[Docket No. 2000-SW-55-AD]

Airworthiness Directives; Eurocopter France Model AS332C, L, L1, and L2; AS350B, BA, B1, B2, B3, and D; AS355E, F, F1, F2, and N; AS-365N2; AS 365 N3; SA330F, G, and J; SA-360C; SA-365C, C1, and C2; SA.316B and C; and SA.319B Helicopters

ACTION: Notice of proposed rulemaking (NPRM).

FIGURE 1 FERRY FUEL TANK

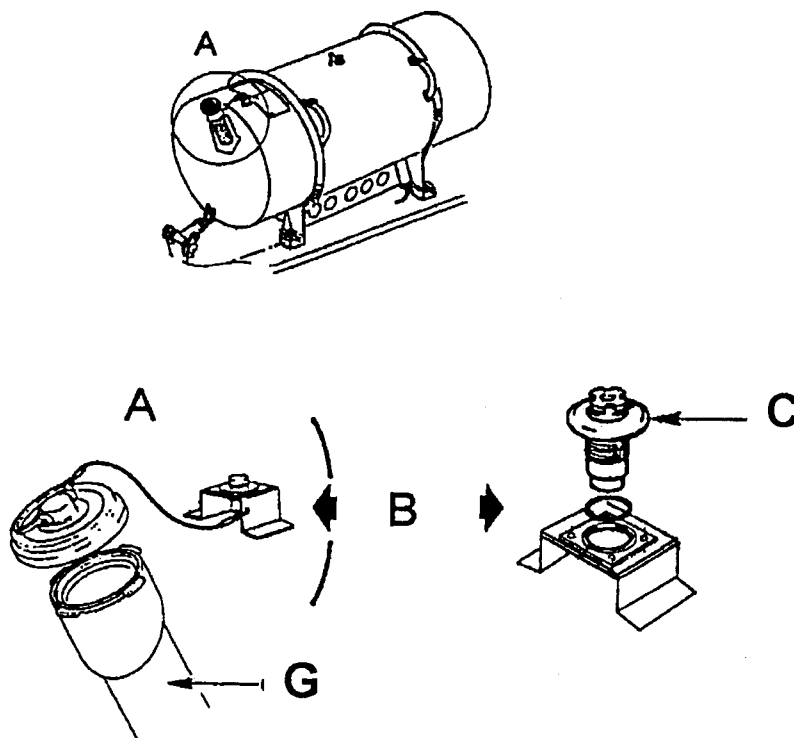
(a) Measure the electrical resistance between the tank electrostatic ground connector (item C) and the tank filler neck (item G) as shown in Figure 1 of this AD. If the value of the electrical resistance is more than 1.5 milliohms, refueling the tank is prohibited. See Figure 1 as follows:
